Intersection ID: 7228	Main Street: CARRINGTON_DR	Cross Street: TILDEN_RD	Location:	N
ADA ID: B2947D1774E2	Ramp Type: Perp	Initial Pass/Fail: Fail	Overall Compliance: No	Severity Score: 22.5

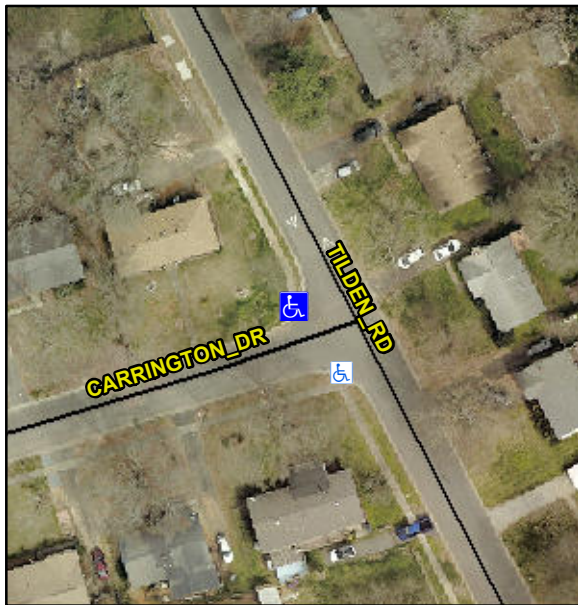
**R304.5.1, R304.2.2, R304.5.3**

Compliance	Description	Data	Compliance	Description	Data
N/A	Ramp Length (in)	37.0	No	Ramp Slope (%)	10.6
No	Ramp Width (in)	45.5	No	Ramp XSlope (%)	4.4
N/A	Flare Type LT	N/A	N/A	Flare Type RT	N/A
N/A	Flare Slope LT (%)	N/A	N/A	Flare Slope RT (%)	N/A
N/A	Flare Traversable LT?	N/A	N/A	Flare Traversable RT?	N/A
N/A	Landing Length (in)	N/A	N/A	DWS Provided?	N/A
N/A	Landing Width (in)	N/A	N/A	DWS Contrast?	N/A
N/A	Landing Slope (%)	N/A	N/A	DWS Length (in)	N/A
N/A	Landing X Slope (%)	N/A	N/A	DWS Full Width?	N/A
N/A	Landing Curb? (Y/N)	N/A	N/A	DWS Offset (in)	N/A
N/A	Shared Landing?	N/A			
N/A	Gutter Ponding?	N/A	N/A	Gutter Slope (%)	N/A
N/A	Gutter Lip Ht (in)	N/A	N/A	Gutter X Slope (%)	N/A
N/A	Painted X Walk1?	No	N/A	Painted X Walk2?	N/A
	X Walk 1 Direction	To S		X Walk 2 Direction	N/A
N/A	X Walk 1 Width (in)	N/A	N/A	X Walk 2 Width (in)	N/A
	X Walk 1 Slope (%)	1.5		X Walk 2 Slope (%)	N/A
	X Walk 1 X Slope (%)	3.4		X Walk 2 X Slope (%)	N/A

### Remove & Replace Entire Ramp.
